REG. PLAN No.	65M-4737
ZONE	RWS2
LOT NUMBER	LOT 60
LOT AREA (m²)	319.00
BLDG AREA (m²)	141.77
LOT COVERAGE (%)	44.44%
MAX HEIGHT (3.5 STOREYS)	
No. OF STOREYS	2 STOREYS

ROUNDEL HOMES INC. (PH-2)

LOT No. 60

CURRENT DRIVE

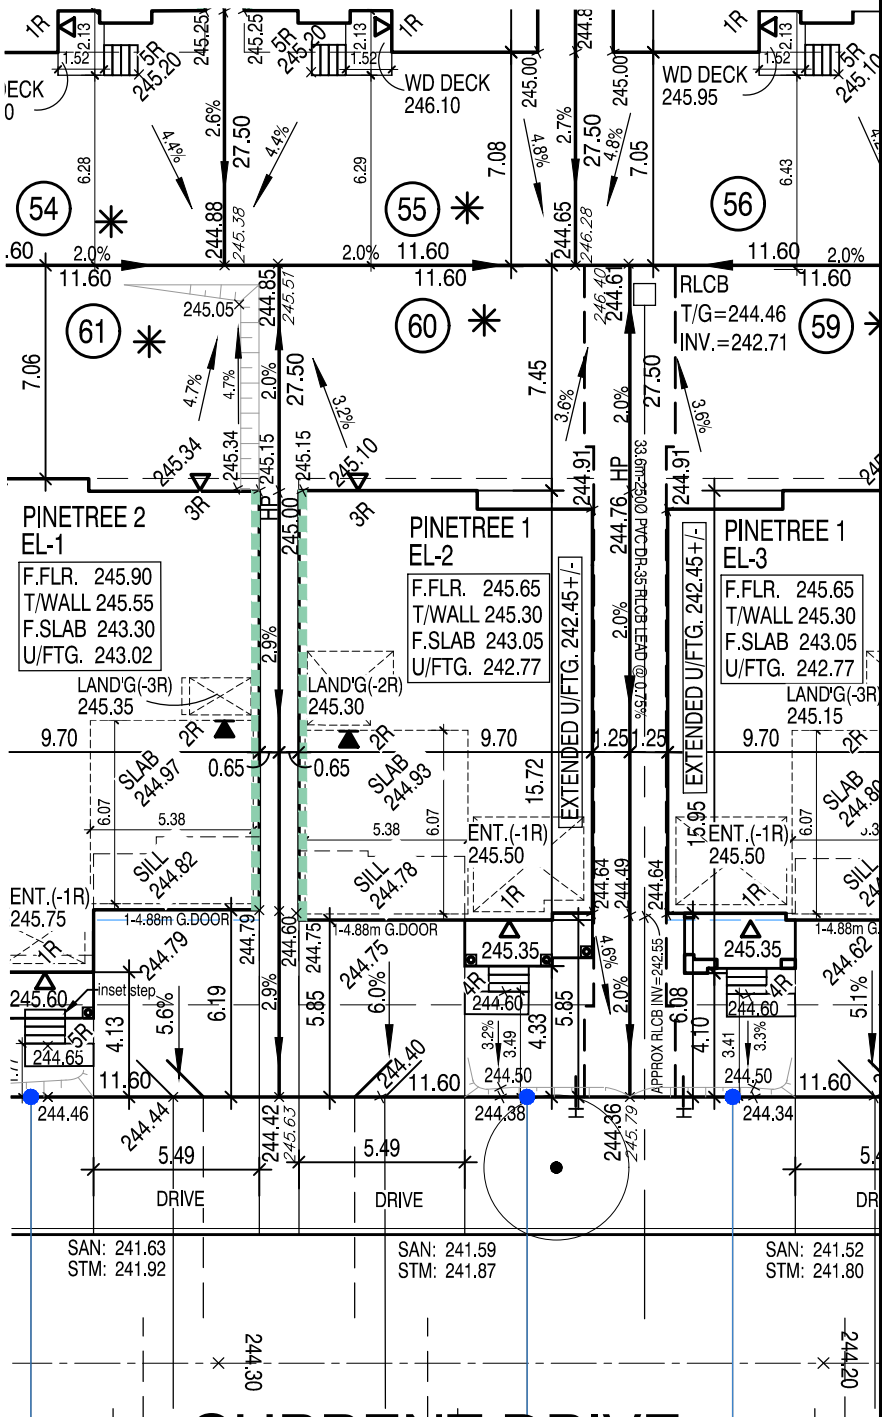
No unprotected openings permitted within 1.2 metres of the lot line as per 9.10.14 of the Ontario Building Code.

45 MINUTE RATED WALL
WITH SIDE YARD < 1.2m
